Service Letter

Service Bulletin No. SL CG 125-1006, Initial Issue
Date: June 30, 2022
Subject: Modify the HPP J29 Plug Connection
Type affected: TAE 125-02-125 (CD-170)
Models affected: The following engine S/N are affected

Correction: Conversion of connector shells

Figure 15

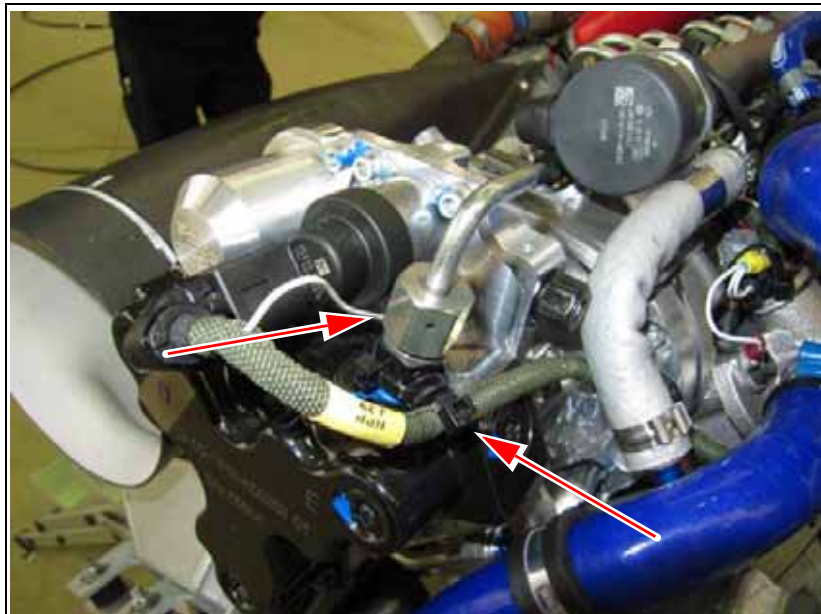
13. Connect shield connector and fix cable with cable tie.
